Colorado Department of Health  
Hazardous Materials & Waste Management Division

Comments

DRAFT

RFI/RI WORK PLAN

GENERAL CONCEPTUAL MODEL

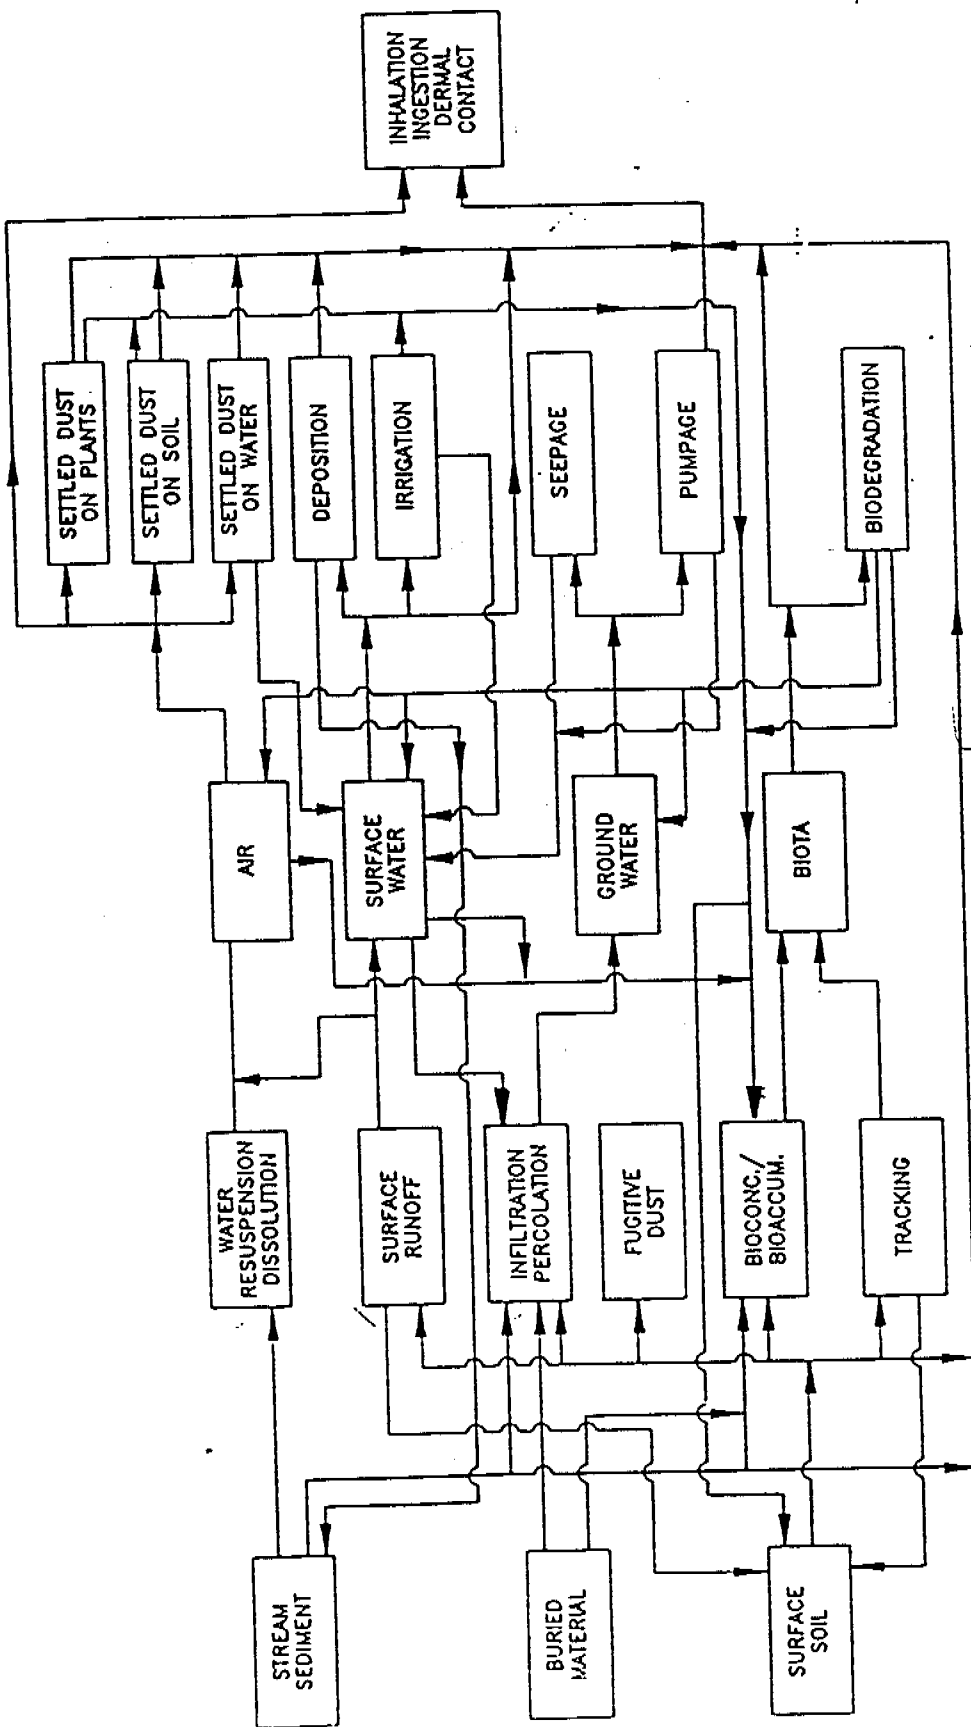
Figure 2.5-2: The conceptual model flow chart presented here is not sufficient to determine whether the proposed FSP is adequate to provide data on each pathway for the Baseline Risk Assessment and Environmental Evaluation. DOE must ensure that each pathway is covered by the sampling. Attached is a General Conceptual Model that may be helpful in redeveloping the flowchart. Please note that additional primary and secondary release mechanisms are shown on the example. DOE need not, and should not, incorporate this example into the work plan verbatim, but should fully consider all possible and complete pathways.
